October 22, 2015

To: Rapid City Public Works Committee Members

Subject: Request by PAJO Properties, LLC that the City Require Rapid City Regional Hospital to Re-grade its Lots 14-17, Block 1, Rapid River Subdivision to Comply with the State of South Dakota's Planned Jackson Boulevard Drainage System

Approximate Flow Areas Provided by Different Drainageways at RCRH's Lot 14

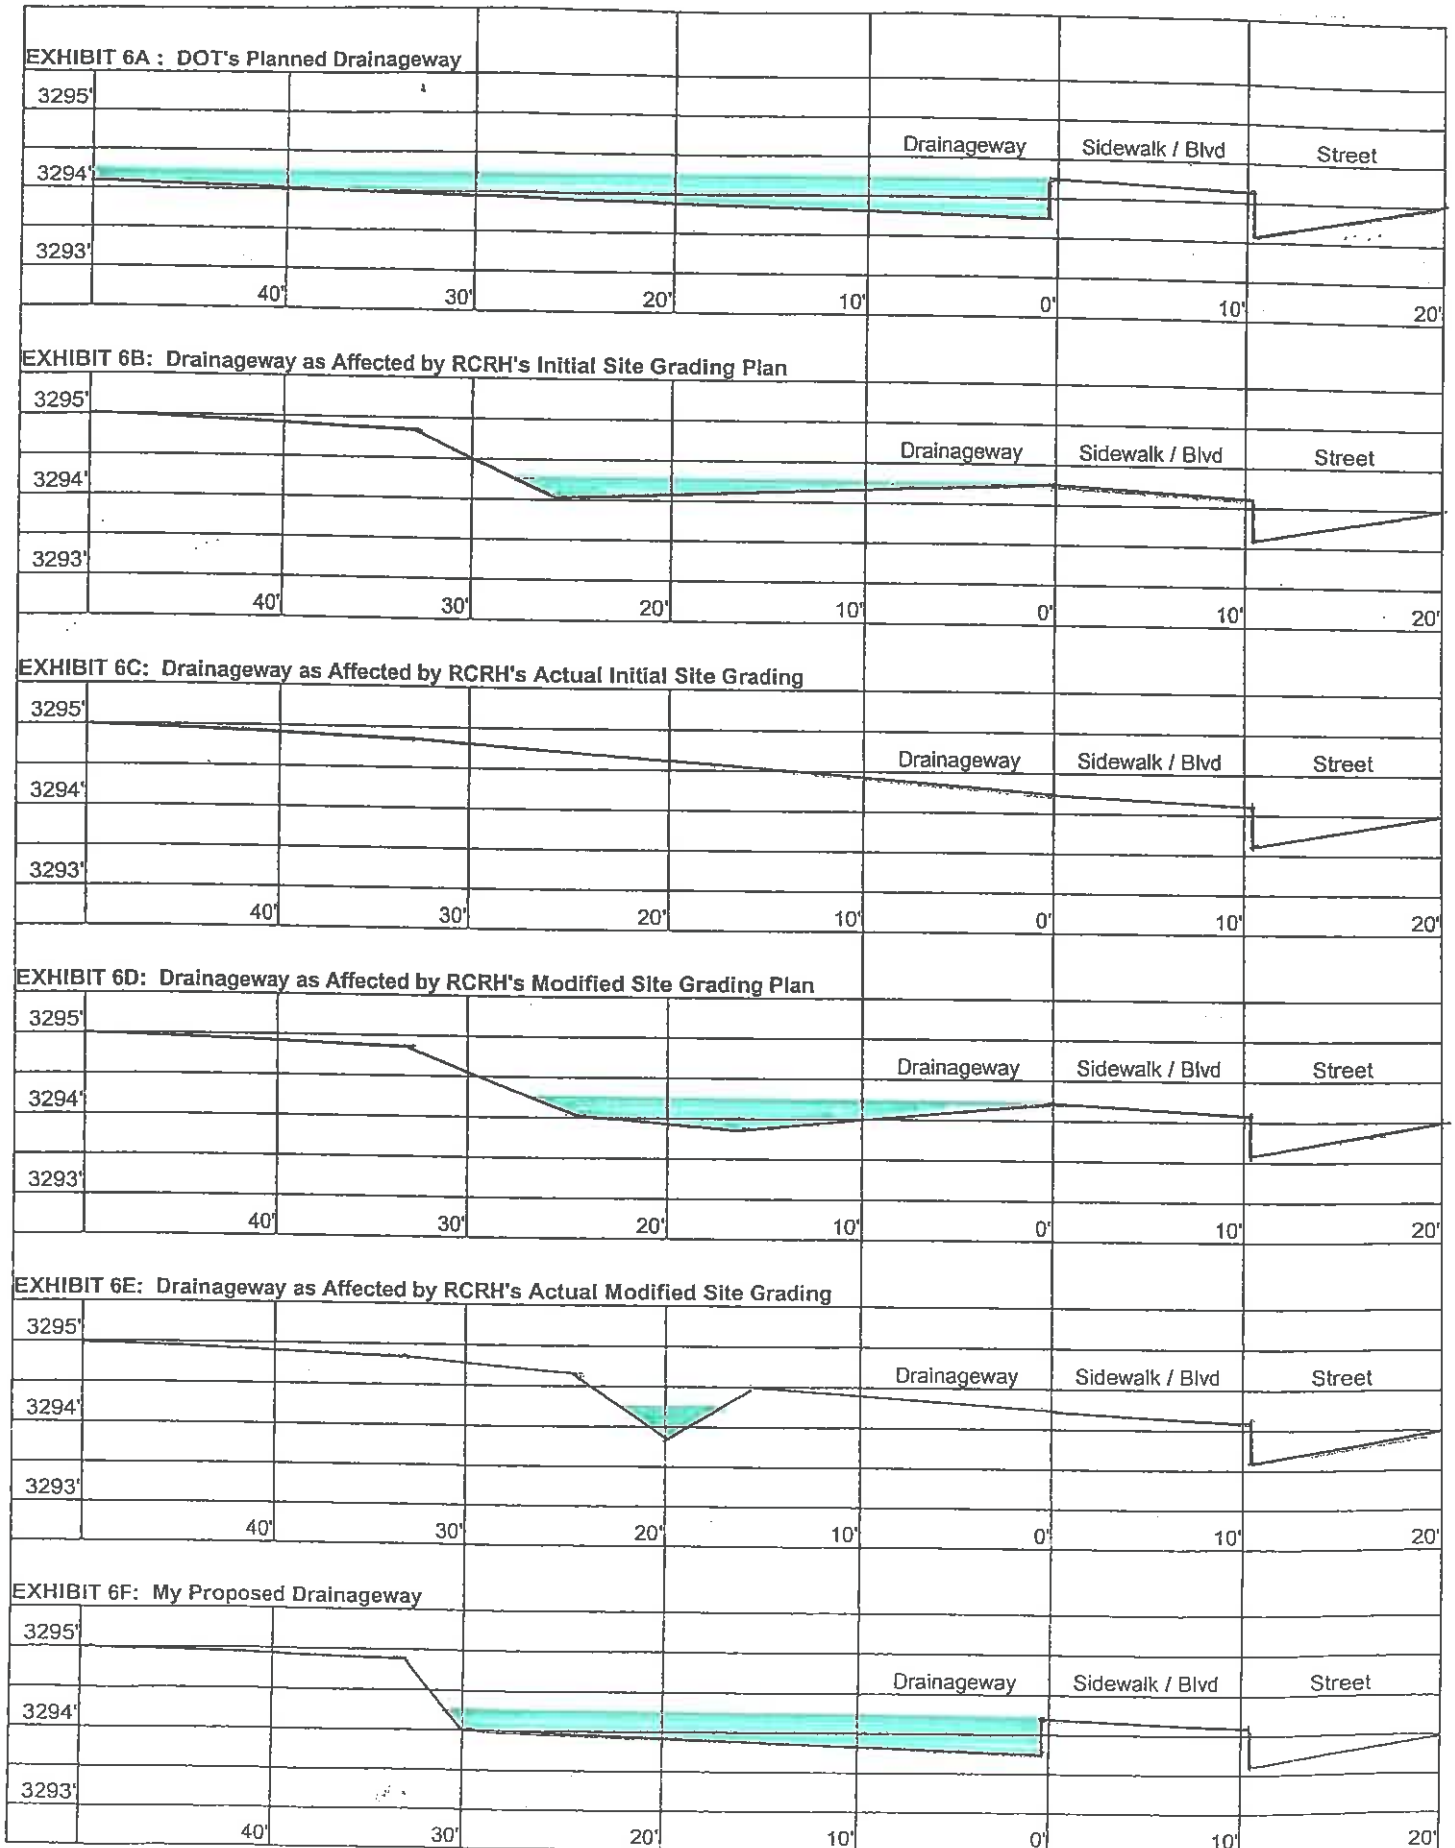
10. When RCRH finally graded and landscaped its southwest corner sometime around June/July 2014, it did not grade it as its architect/engineer had proposed it could be graded at our February 4, 2014 meeting. It did not even grade it as it showed it would in its site grading and drainage plan submitted for its building permit. It graded it instead to have even higher elevations than its site grading and drainage plan showed [Exhibit 6C v. Exhibit 6B]. This meant the drainageway would now be blocked worse at my property's downstream border.

13. Following the City's letter to RCRH, I sent RCRH a letter on October 17, 2014 to remind it of the changes that its architect/engineer had offered to make at our February 4, 2014 meeting [Exhibit 10]. Unfortunately, now that its site grading had been completed, RCRH apparently no longer was willing to change its southwest corner as its architect/engineer had offered. On June 15, 2015, I received a copy of the proposed site grading revisions it now was willing to make [Exhibit 11]. Its proposed revisions were going to provide me only a very small and slightly sloped drainage channel across its southwest corner. I objected to these proposed revisions to both RCRH and the City Engineer, because they would not provide very much drainage at all (estimate 5 cfs). They certainly were not going to provide me the drainage that

DOT's drainageway would have provided [Exhibit 6D v. Exhibit 6A], or even "adequate drainage" during many storms.

15. RCRH has now re-graded its southwest corner. It did this on September 21-22, 2015. Again, its grading does not comply with the site grading modification plan it submitted to the City's Engineering Department. The drainage channel it has provided will provide even less drainage (estimate 4 cfs, if full) than the one shown in its site grading modification plan [Exhibit 6E v. Exhibit 6D].

I am requesting that the City require RCRH to change its southwest corner's site grading as shown in Exhibit 6F and Exhibit 13. These changes will not provide me the same unimpeded drainage during all storms that DOT's drainageway would have provided me. However, they will provide me at least the best possible drainage that RCRH's southwest corner can provide. To provide me the same unimpeded drainage that DOT's drainageway would have provided me, RCRH would need to change a large area of its parking lot, in addition to changing its southwest corner. However, in the spirit of being reasonable, I am not requesting that it be required to change its parking lot. However, I am requesting that it be required to change the landscaped area west of its parking lot. Specifically, I would like the City to require RCRH to install some curbing along Lots 13/14's shared border to make this area more like a landscape island. Hopefully, this area then will not be able to drain onto my parking lot. Also, I would like RCRH to be required to remove the dilapidated chain link fence that runs along this area; because it is not only ugly, but a potential injury hazard. I have asked previously, but it has refused to do this. Finally, I would like to be able to add some bushes (at my cost) to this area west of RCRH's parking lot to make it more attractive from my property's viewpoint. I would be willing to be responsible for the care of these bushes. However, in return for these costs, I would ask that the City allow me to receive some landscaping points for these bushes.

RCRH's Modified Site Grading Plan Approved by City's Engineering Department

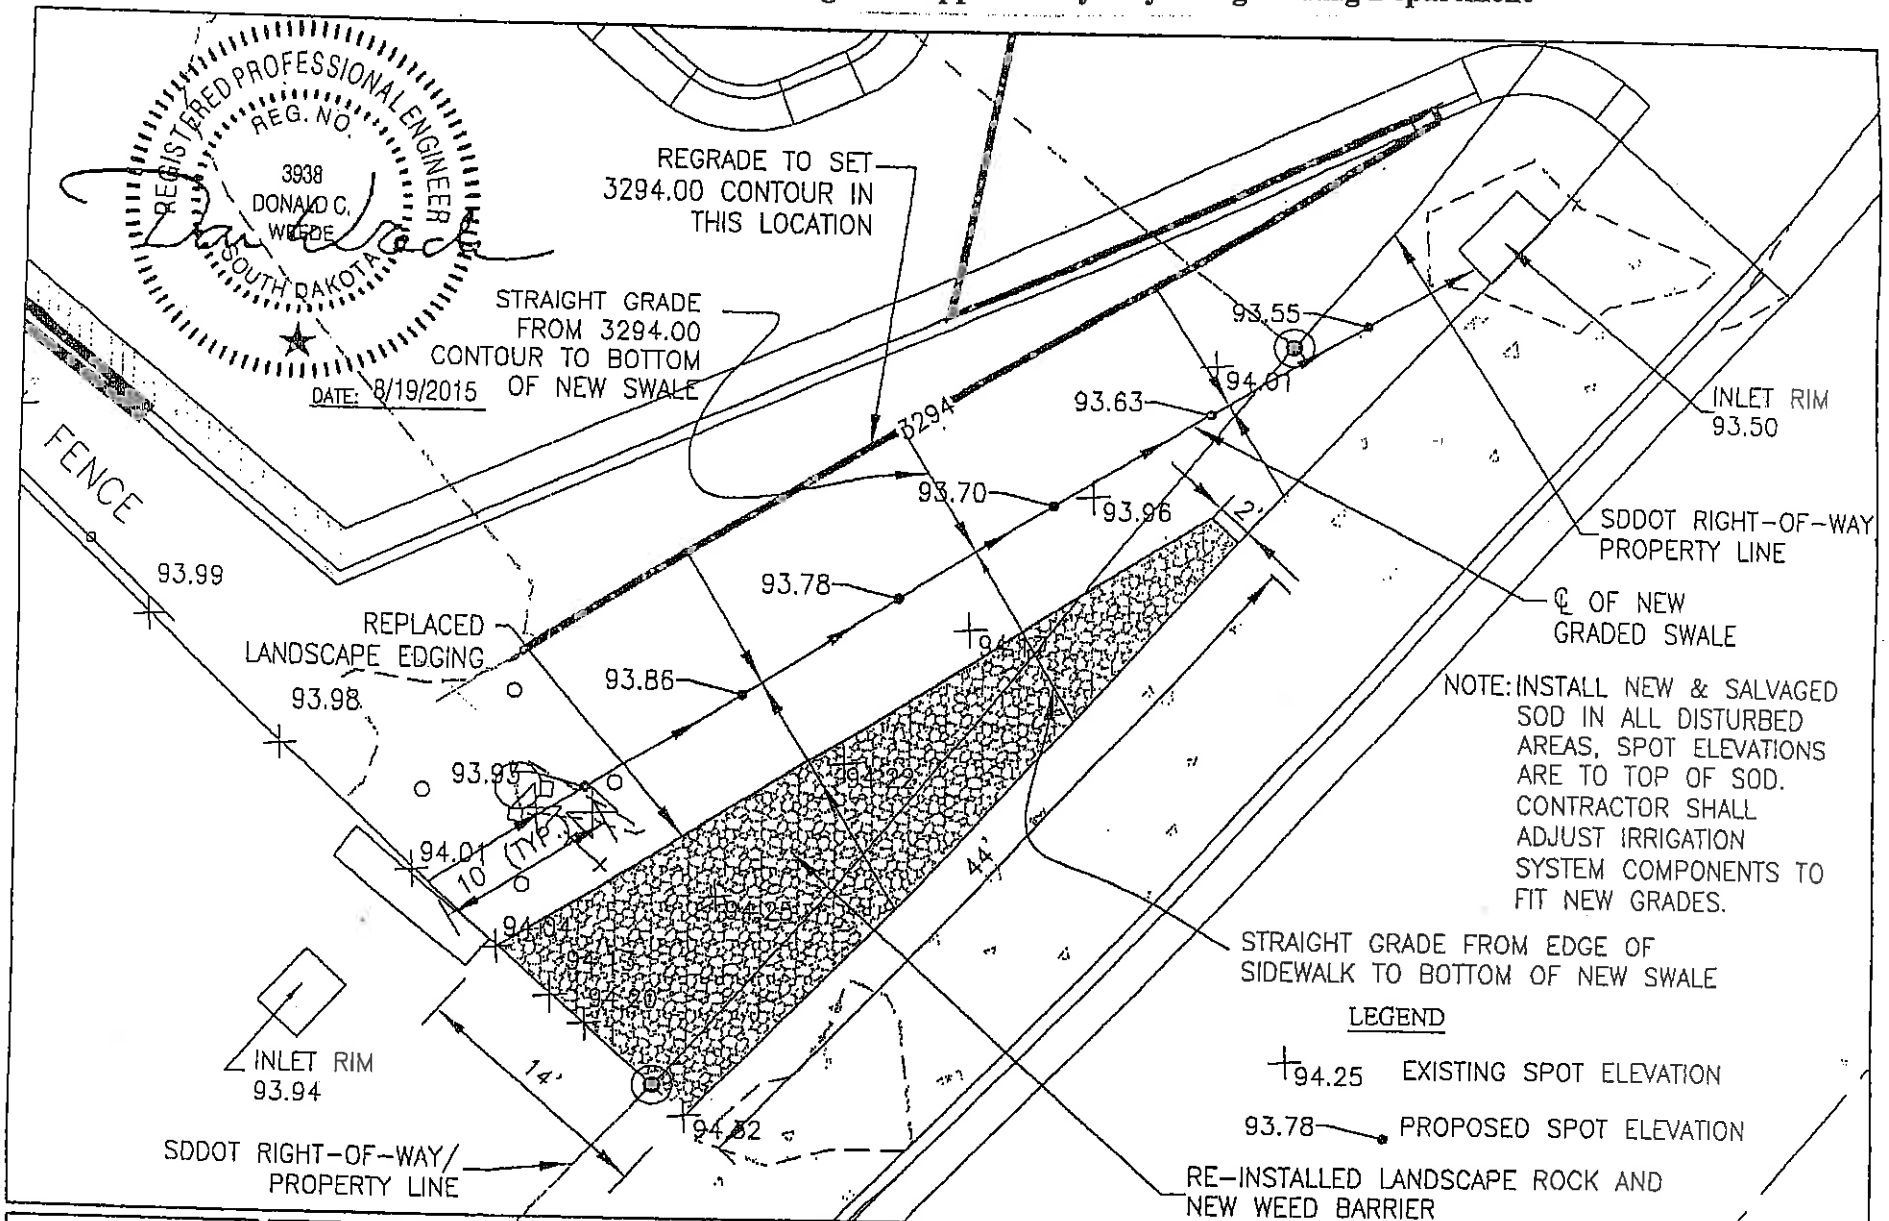
14. In spite of my objections, RCRH submitted its proposed site grading modification plan to the City's Engineering Department on August 26, 2015 for its approval; and the City Engineer approved its proposed plan. He approved the plan, because it "appear[ed] to maintain the original intent of the approved construction drawings associated with the commercial building for this property" [Exhibit 12]. He apparently had abandoned his mandate that RCRH provide "adequate drainage."

Don Wrede with TSP, Inc. submitted a revised site grading plan to the City on August 26, 2015 for the southwest corner of the Regional Urgent Care West property located at 2116 Jackson Blvd, Rapid City, South Dakota 57702. The proposed revisions appear to maintain the original intent of the approved construction drawings associated with the commercial building permit for this property, City Permit #CIPB15-5857, issued by the City on December 20, 2013. The City takes no exceptions to the proposed revisions.

My Requested Site Grading Modification Plan

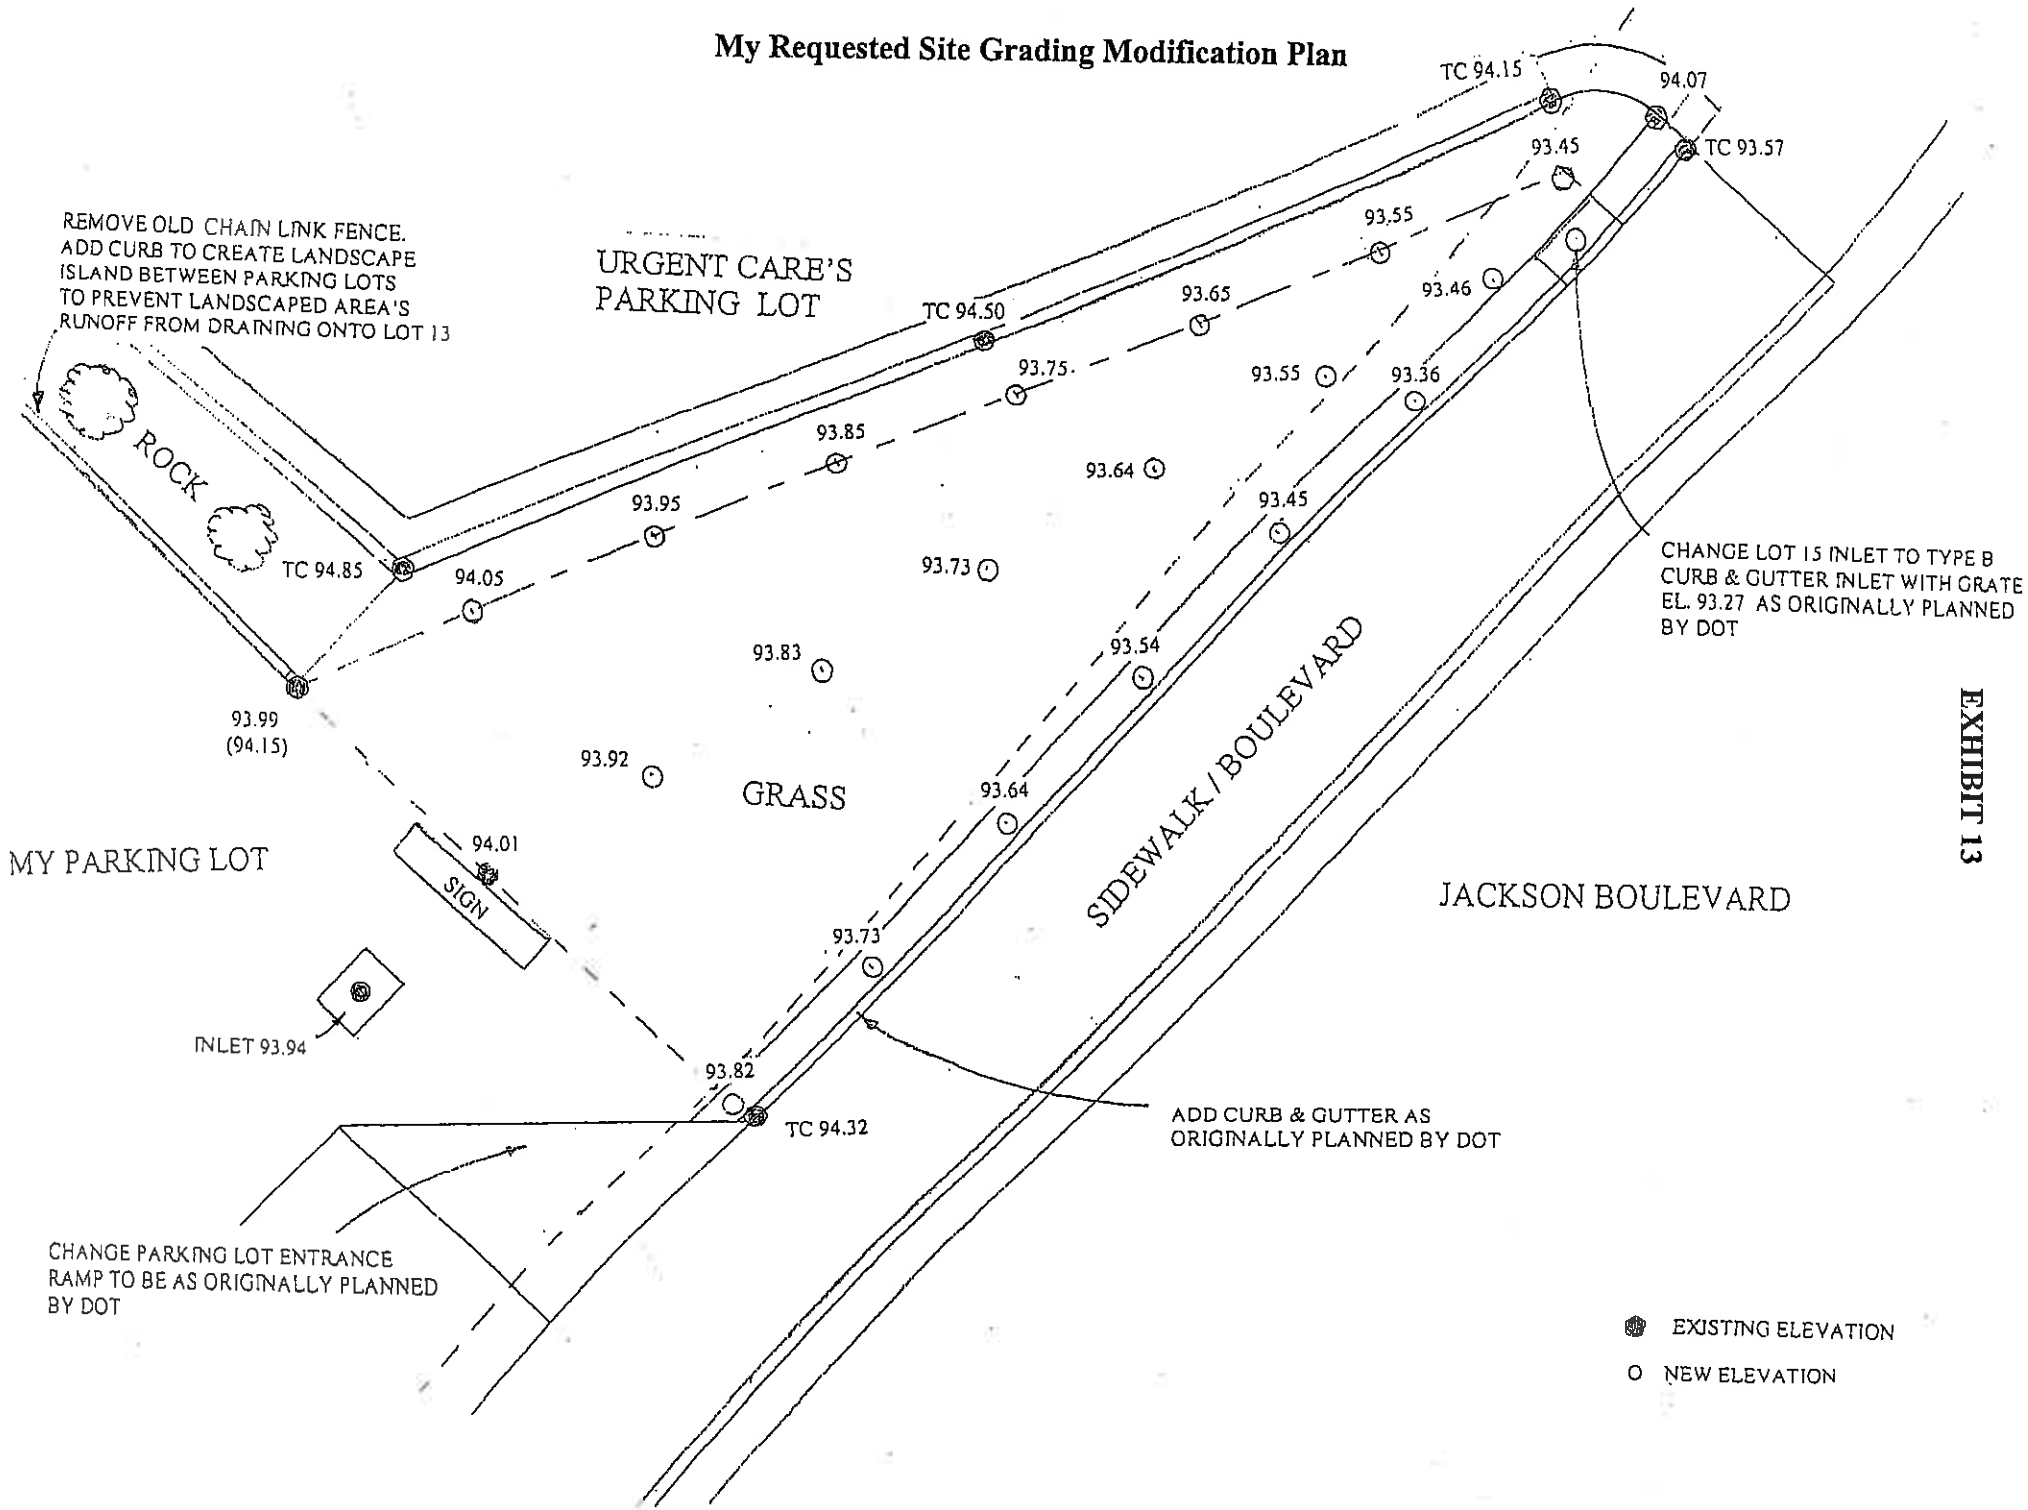
5. I am requesting that RCRH be required to return DOT's Lot 15 inlet to its originally planned elevation (3293.27'). At this elevation, RCRH's southwest corner could have a channel slope of approximately 1.1% from my property line's lowest point (approx. 3294.01 per RCRH's modified site grading plan) to this inlet. At the inlet's current elevation (3293.57, per DOT), the channel's slope is only approximately 0.6%. Again, a channel's slope affects how much flow the channel can carry. The greater its slope, the more flow it can carry. This is one reason I would like the inlet returned to its design elevation. I also would like it returned to this elevation because an inlet's capacity to drain increases with the depth of the water over it. If the inlet is lower, the southwest corner's channel will be a deeper. This will allow the water that can accumulate over the inlet to be deeper, which will allow it to drain at a greater rate (e.g. per DOT, Lot 15's inlet would have a drainage capacity of 2.7 cfs at 3" depth, but 7.7 cfs at 6" depth).
